ROADWAY AND GIRDER LEVEL WESTBOUND
(LIGHTING AND ELECTRICAL SYSTEMS)

E-10

"CCO ____ DRAFT"
08/25/2010

ROADWAY LIGHTING POLE PLAN LOCATION-SHEET 29
OAKLAND APPROACH STRUCTURES

ROADWAY CONDUIT PLAN

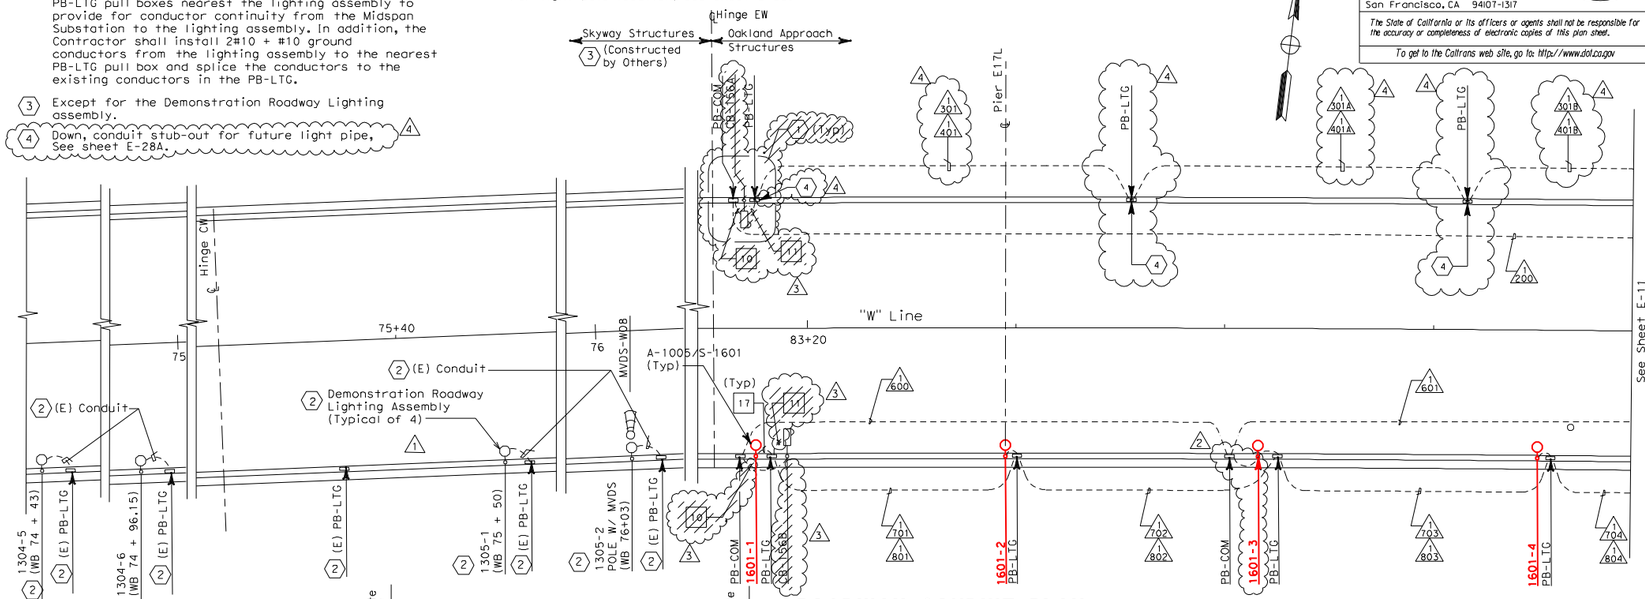
1. ~~For Call Box conduit installation, see sheet E-39.~~
2. The Demonstration Roadway Lighting Assembly is to be powered from the Skyway Westbound Midspan Substation. The 480 V conductors + ground from the Midspan Substation to the pull box (PB-LTG), adjacent to the lighting assembly, have been installed under a different contract. The Contractor shall splice the existing 480 V + ground conductors in the two PB-LTG pull boxes nearest the lighting assembly to provide for conductor continuity from the Midspan Substation to the lighting assembly. In addition, the Contractor shall install 2#10 + #10 ground conductors from the lighting assembly to the nearest PB-LTG pull box and splice the conductors to the existing conductors in the PB-LTG.
3. Except for the Demonstration Roadway Lighting assembly.
4. Down, conduit stub-out for future light pipe, See sheet E-28A.

MARK	DATE	DESCRIPTIONS	REV	CK	CCO NO.
4	8/29/08	Added conduit nos. 1301A, 1301B, 1401A, 1401B, PB-LTG. sheet note 4, Re-routed conduits 1301 and 1401	EJL	ECR	LIGHT PIPE
3	8/29/08	Deleted CB-156A, CB-156B, Project Notes 10 and 11, Sheet Note 1 and Call Box Reference Note.	EJL	ECR	18S1
2	8/29/08	Added Conduit To Pole 1601-3	EJL	ECR	Ltg. Pole Base
1	1/9/08	Added Demonstration Pole 1304-5	EJL	SE	39
